INDESIT company

Model type:
DI71SIIT

Commercial code:
F027949

Photo N1045062FIG1 illustrates the bottom of the dishwasher with EVO structure.

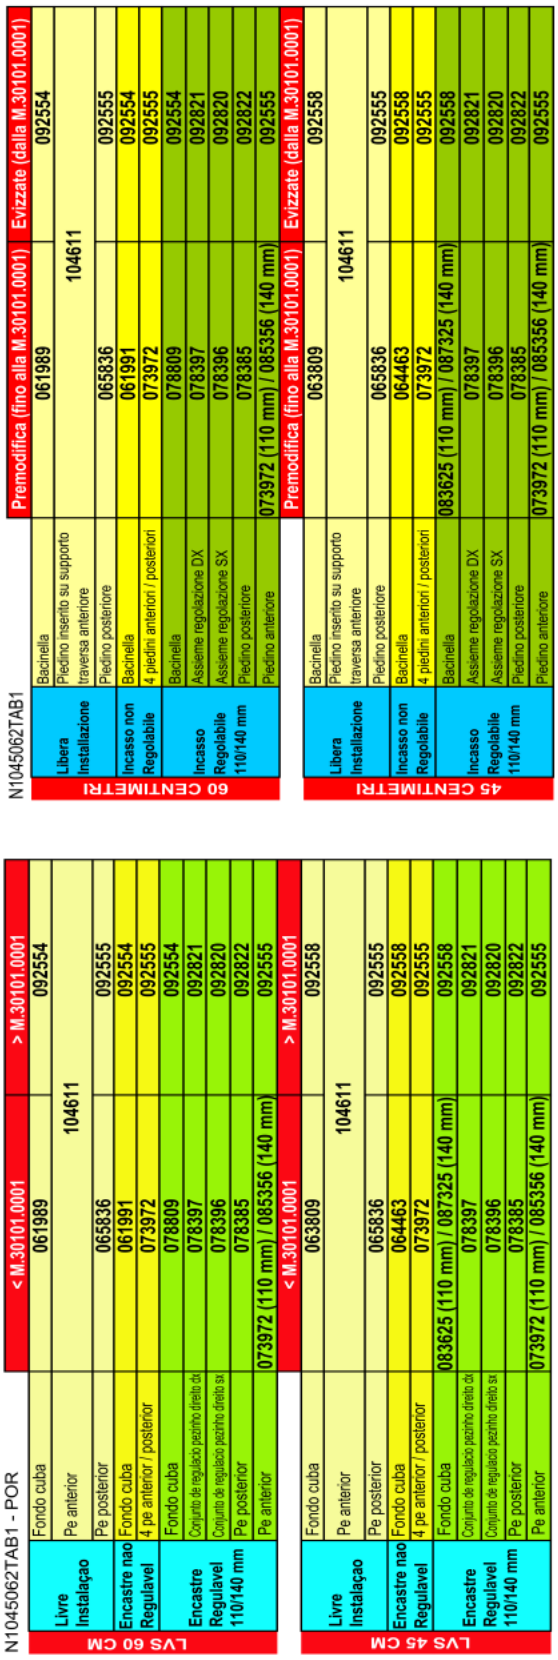
n1045062: Introduction of a new DW EVO structure

From serial number 30101.0001, all dishwasher models affected by this modification have been produced with EVO structure. These models have been equipped with NEW TRAYS AND NEW FEET (see N1045062TAB1).

PREMODIFICATION:
Tray: 083625 (for commercial code 28490) 078809 (for commercial codes 26043-23520-28088);
Tray rear feet: 078396-078397-078385;
Tray front feet: 073972;
Front feet supports: 065836(Rohs 143584);
Feet supplied with plinth accessories assembly: 034261;

EVO STRUCTURE:
Tray: 092558 (for commercial code 28490) 092554 (for commercial code 26043-23520-28088);
Tray rear feet: 092820-092821-092822;
Tray front feet: 092555;
Front feet supports: 065836;
Feet supplied with plinth accessories assembly: 034261.

Regulation assembly DX/SX Sat codes 078397 and 078396 will be managed up to stock end, after that they will be replaced by new Sat codes 092821 and092820. The same is for rear foot Sat code 078385 which will be replaced by Sat code 092822.

N1045063

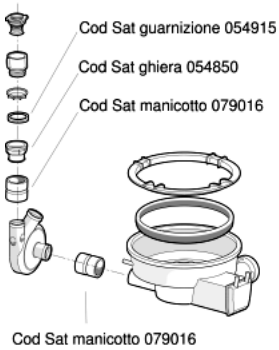
n1045063: Introduction of coupling+ring nut Sat code 093752

From serial number 30224.0001, all dishwashers affected by this modification have been equipped with the new coupling+ring nut assembly Sat code 093752, in place of coupling Sat code 079016, ring nut Sat code 054850 and gasket Sat code 054915.

Ring nut Sat code 054850 will continue to be available from the spare parts warehouse while stocks last, and coupling Sat code 079016 will continue to be stocked because it is still used for the tank-volute connection.
Picture N1045063 illustrates the premodification structure in FIG1 and the new structure in FIG2.
